# Built & Natural Environment Team

<b>Application Reference:</b>	<b>WD/2025/0922/MEA</b>
<b>Site:</b>	<b>LAND WEST OF UCKFIELD - OWLSBURY FARM, HORSTED GREEN, LITTLE HORSTED, TN22 5T</b>

<b>From:</b>	David Massheder, Senior Arboricultural Officer, Planning & Environmental Services, Wealden District Council	<b>Date:</b>	27/10/2025
--------------	---	--------------	------------

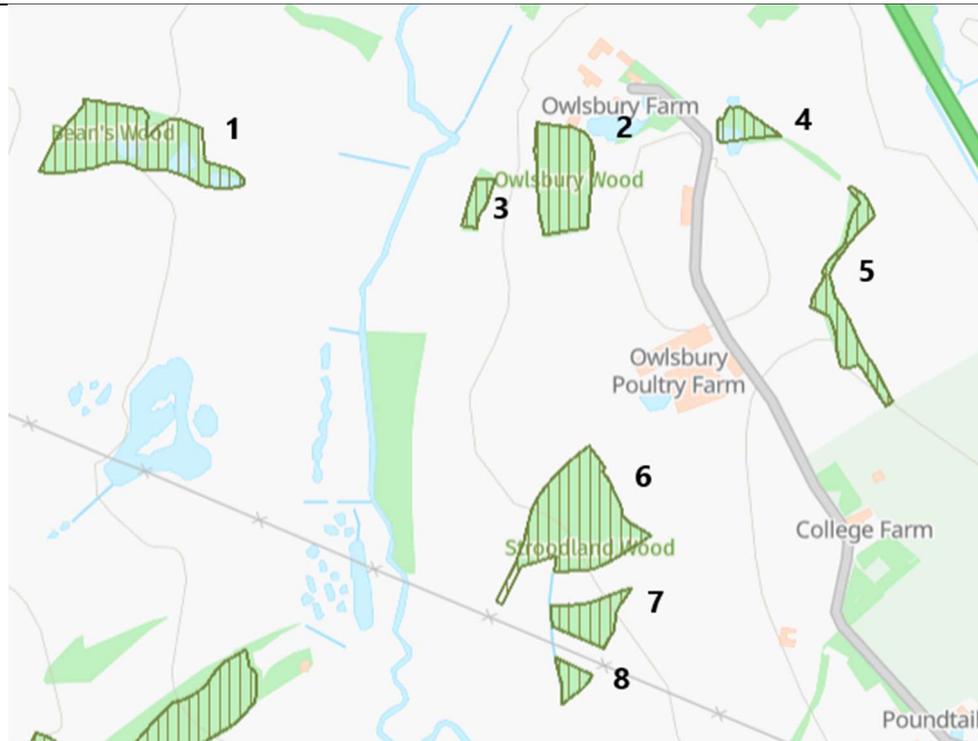
The site hosts a well distributed number of ancient woodland (AW) parcels, identified by natural England mapping and regarded as irreplaceable habitat (Ancient Semi Natural Woodland). It is therefore essential that any site layout is fully informed by these constraints. The location and distribution of the AW parcels can be seen on the attached extract from Natural England's Magic Mapping database:

The woodland parcels are identified as Bean's Wood (1); Owlsbury Wood (2); Owlsbury Wood ext (3); Owlsbury Farm Shaw (4); Honeypot Shaw (5); Stroodland Wood (6); Stroodland Wood 2 (7) and Stroodland Wood 3 (8). It is noted that Owlsbury Wood lies outside of the development red line boundary and is not identified as AW on the Green Infrastructure Parameter Plan (D3313-FAB-00-XX-M2-Y-057). However, given its location on the boundary of the application site, it will still be influenced by the development, hence its inclusion in this consultation response.

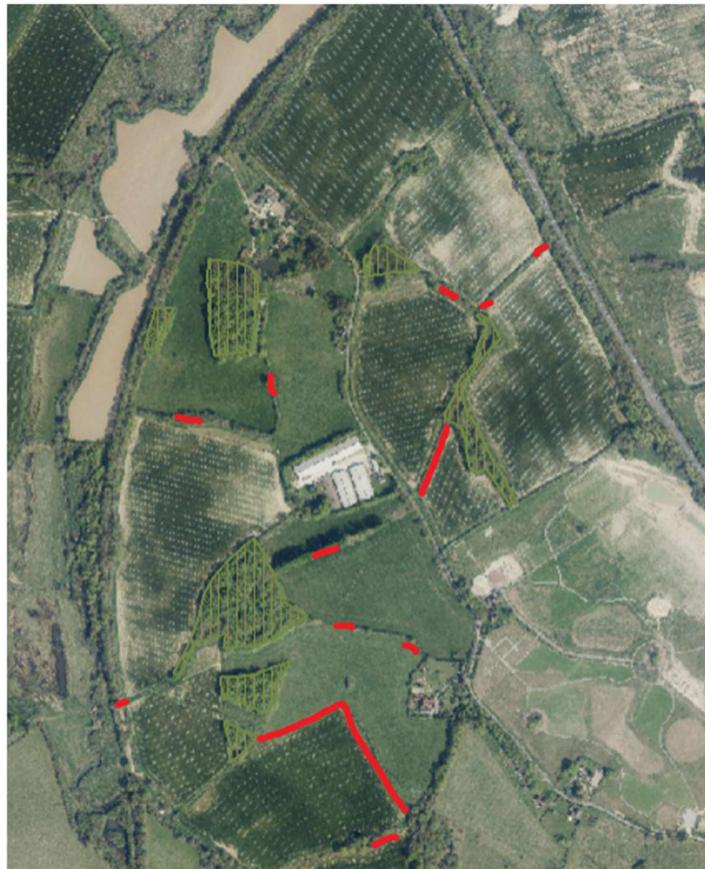
In line with Paragraph 192 of the NPPF, development should promote the conservation, restoration and enhancement of priority habitats, ecological networks and the protection and recovery of priority species; and identify and pursue opportunities for securing measurable net gains for biodiversity. The submitted proposal does not appear to follow this direction (in relation to AW) and in fact would exacerbate existing fractures in connectivity across the site and it fails to take advantage of the opportunities available for real gains. Proposals should seek, in conjunction with the buffering described above, to reconnect existing AW parcels and to improve connectivity across the entire site. The map extract below illustrates approximate locations of proposed new breaks in connectivity across the site.

Owlsbury Farm Shaw and Honeypot Shaw would lose significant connectivity with the wider site with the loss of H224 and part of G195. The removal of both connecting ends of H99 would isolate Honeypot Shaw from the well vegetated eastern boundary of the site and the existing linear tree lines to the west, within the site at G98/G100. The linear connection between Stroodland Wood and the wider site, formed by H264 to the far western boundary tree line T261-T262, and the woodland along the former railway line G107 would similarly be severed. Further to the south Stroodland Wood would be completely disconnected from the southeast boundary tree line as a result of the proposals to remove significant lengths of hedgerow at H250 and H34. The current proposals will result in increased fracturing of AW parcels, loss of hedgerows and wider connectivity leading to isolation of habitat.

In line with the NPPF, joint NE/FC standing advice for AW and British Standards in relation to trees and development, the existing site constraints should inform the design layout from the earliest stages. Existing gaps or currently used access points in hedgerows should be utilised before any additional new openings are proposed. Stroodland Wood has been historically bisected by an overhead power line, but opportunities to reconnect the individual woodland parcels are still available and planting can be carried out as long as minimum safety clearances/exclusion zones are observed. Low growing trees and understorey species could easily be utilised to reconnect this habitat as part of wider landscaping measures.
